G3NO-2008-00007

SUBJECT: Responses to NRC Requests for Additional Information, Letter No. 03
(GG3 COLA)

REFERENCE: NRC Letter to Entergy Nuclear, Request for Additional Information
Letter No. 03 Related to SRP Section 12.03-12.04 for the Grand Gulf
Combined License Application, dated September 12, 2008 (ADAMS
Accession No. ML082560372)

**Grand Gulf Nuclear Station, Unit 3
COL Application
Part 2, FSAR**

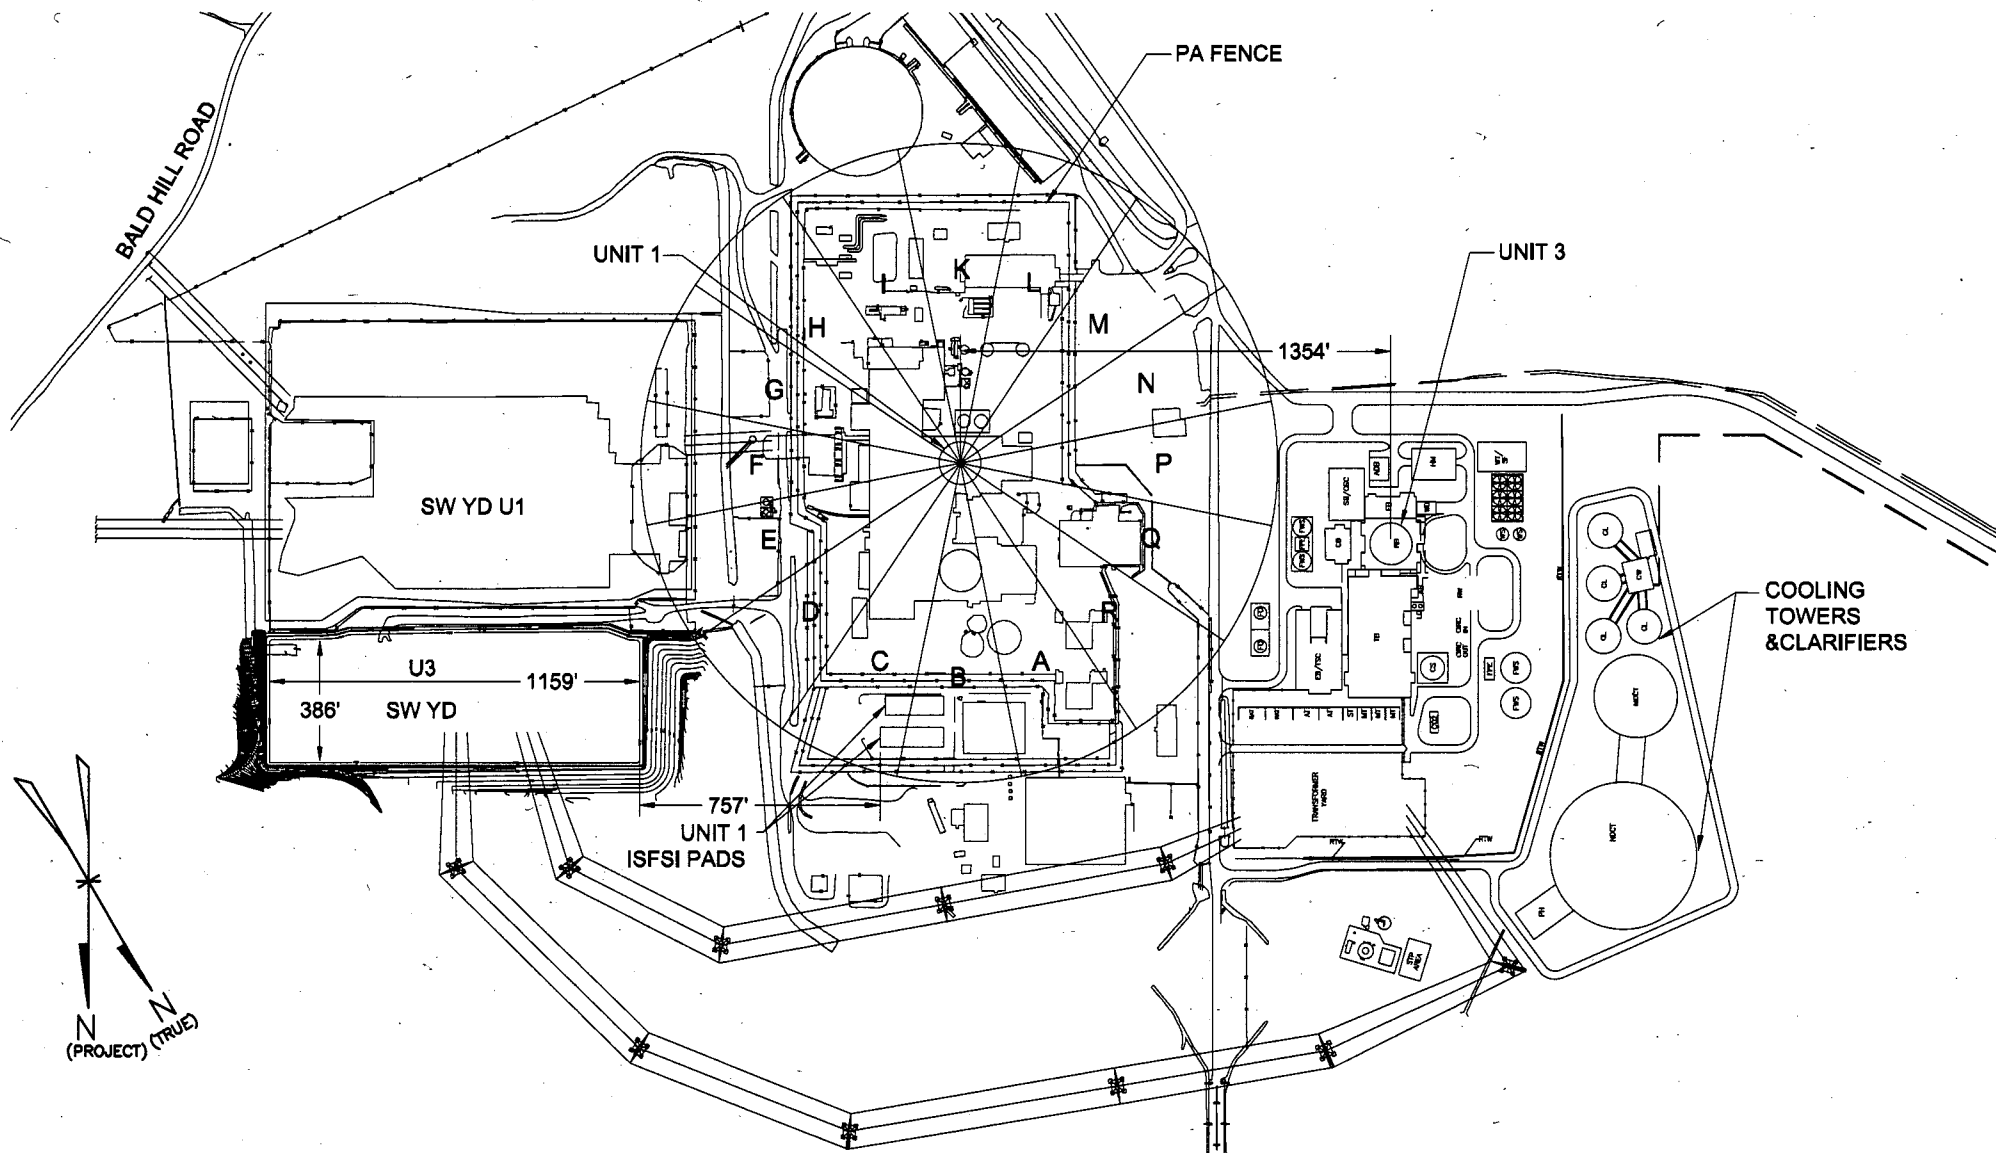
FSAR, Appendix 12CC, Subsection 12CC.3.3.2 provides an analysis of the direct radiation dose from the Unit 1 independent spent fuel storage installation (ISFSI). A review of the direct radiation dose rates from the Grand Gulf Unit 1 ISFSI indicates potential radiation levels in excess of the 10 CFR 20.1301(a)(2) limit of 0.02 mSv/hr (2 mrem/hr) at the north end of the ISFSI. This section states that the Unit 1 ISFSI will be located on the north side of the Unit 1 site inside the protected area fence. The gamma dose rates and the distance from the ISFSI to the Unit 3 construction area are discussed. The distance from the ISFSI to the closest Unit 3 construction area has been estimated based on Figure 2.4.1-201. A review of the information in Subsection 12CC.3.3.2 and an examination of Figure 2.4.1-201 indicates that it is not clear where the ISFSI is located and where the dose rate exceeds 2 mrem/hr.

- a) Provide a site drawing showing the location of the ISFSI with respect to the Unit 3 construction site.
- b) Provide a figure showing the potential combined gamma and neutron dose rate at the ISFSI fence line and the location of the Unit 1 protected area fence with respect to the Unit 3 construction site. Additionally, indicate any areas outside the Unit 1 protected area fence where the dose rate might exceed 2 mrem/hr. Describe any controls to insure that doses to construction workers will not exceed 2 mrem in any one hour in these areas.

The Grand Gulf Unit 3 Construction Worker Dose analysis has been updated to address increased gamma doses at the Unit 1 protected area fence and increased gaseous radiological effluent from Unit 1 measured in recent years. In addition, the methodology used to estimate the direct radiation dose from the Unit 1 ISFSI has been corrected and updated. The updated annual and maximum hourly direct dose analysis and results, 81.1 mrem and <2 mrem/hr, respectively, are provided in the proposed revision to FSAR Appendix 12CC included with this attachment. Necessary information is provided in FSAR Appendix 12CC to evaluate the bases and assumptions used in the analysis and for conducting an independent confirmation of compliance with NRC regulations with the exception of a figure showing the ISFSI location relative to principle construction areas, and isodose curves used in the analysis of the ISFSI. A figure showing the ISFSI location relative to the construction areas (Figure 1), and the far-field isodose curves used in the Unit 1 dose analysis of the ISFSI (Figure 2) are provided below.

The GGNS ISFSI is nearest the protected area fencing on the north and east sides of the ISFSI (see Figure 1 with response to RAI 12.03-12.04-1 in Attachment 1). In these areas, the fencing consists of three fences: an outermost nuisance fence, the Protected Area (PA) fence and an interior floppy fence. Each fence is separated by 20 feet; therefore, a 20' isolation zone is maintained on each side of the north PA fence. The near field gamma dose rate and neutron dose rate associated with a completely loaded ISFSI array varies within the confines of the ISFSI fences from 25 to 0.5, and 4 to 0.1 mrem/hr, respectively. In accordance with the Grand Gulf Unit 1 Radiation Protection Program and Offsite Dose Calculation Manual, surveys of radiation levels in unrestricted and controlled areas are performed to demonstrate compliance with 10 CFR Part 20 dose limits for individual members of the public. Restrictions on access to areas that might exceed 10 CFR 20 dose limits are implemented, as required.

Figure 2
GGNS MCNP Model Far Field Dose Rates

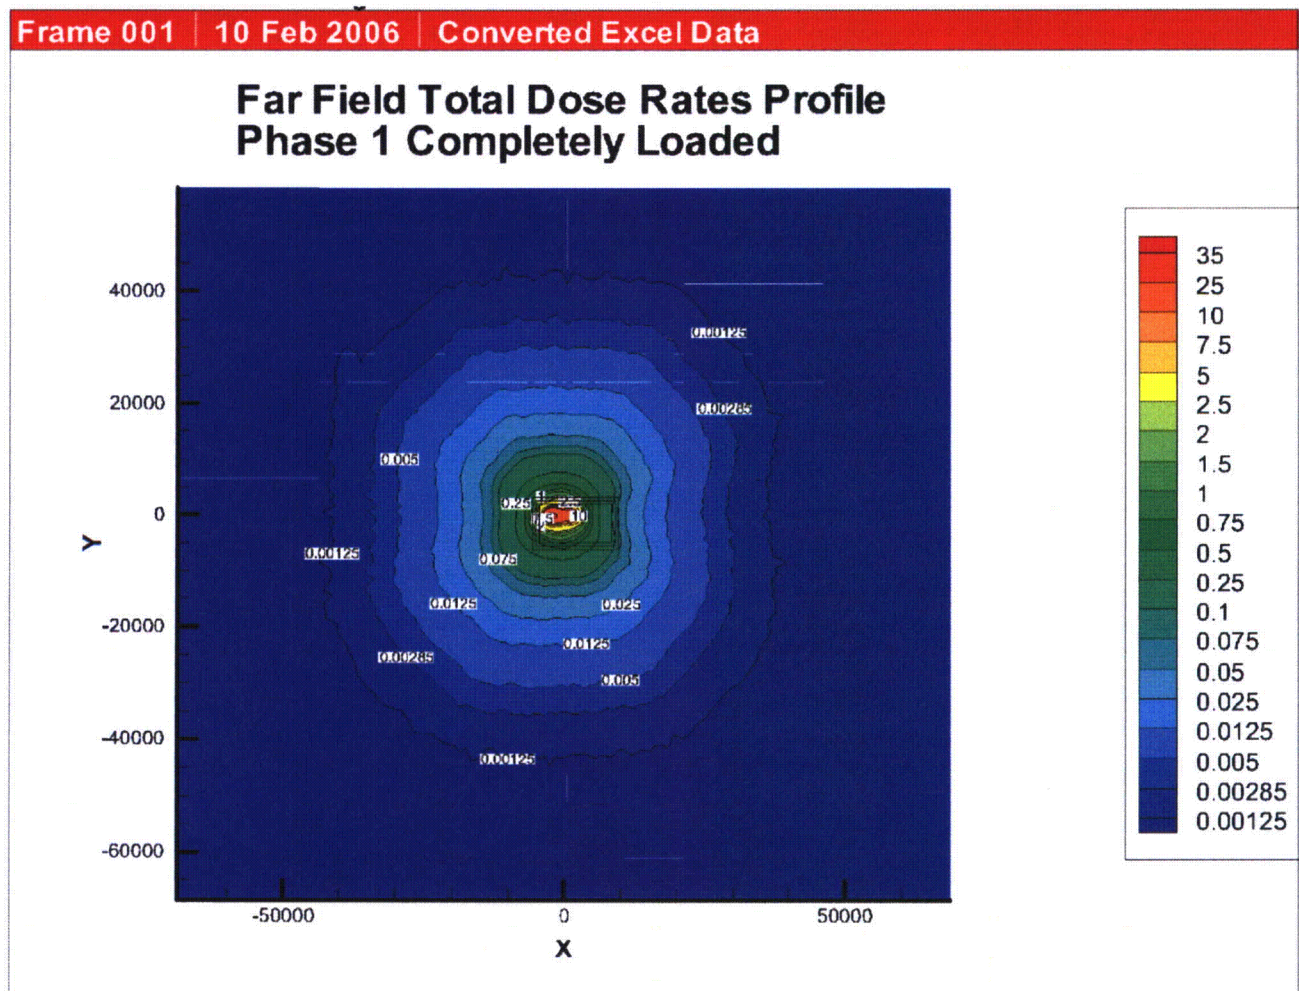
FSAR Appendix 12CC provides an updated analysis of annual construction worker dose. A review of this analysis identifies potential underestimation of construction worker dose from direct radiation from the Nitrogen-16 source from the main turbine building and direct radiation from the Unit 1 independent spent fuel storage installation (ISFSI). The gamma doses measured at the protected area fence during recent years (2005-2007) have increased above the levels found in previous years (2000-2002). These doses are used for the construction worker dose calculation. In addition, the calculation of direct radiation dose to the construction workers from the Unit 1 ISFSI appears not to have considered doses associated with the gamma ray component of the radiation emanating from the individual spent fuel dry casks stored at the ISFSI. Also, the dose calculations appear to have used an incorrect method to estimate the direct dose at 100 meters from the ISFSI confines.

Provide an updated annual and maximum hourly direct dose analysis in Appendix 12CC. Provide sufficient information for the staff to evaluate the bases and assumptions used in the analysis and for conducting an independent confirmation of compliance with NRC regulations. Sufficient information includes, but is not limited to, maps identifying the locations of, and distances between, the ISFSI (and other radiation sources) and construction worker sites, radiation source strengths, and any calculational measurements and isodose curves used in the analysis.

The Grand Gulf Unit 3 Construction Worker Dose analysis has been revised to update the methodology used to estimate the direct radiation dose from the Unit 1 ISFSI. FSAR Appendix 12CC draft revisions reflecting the updated construction worker dose analysis bases, assumptions and results are included with the response to RAI 12.03-12.04-1 in Attachment 1 to this letter. The response to RAI 12.03-12.04-1 also includes a site plan showing the location of the ISFSI with respect to principle Unit 3 construction areas as well as a figure showing the far-field isodose curves used in the dose analysis of the ISFSI.
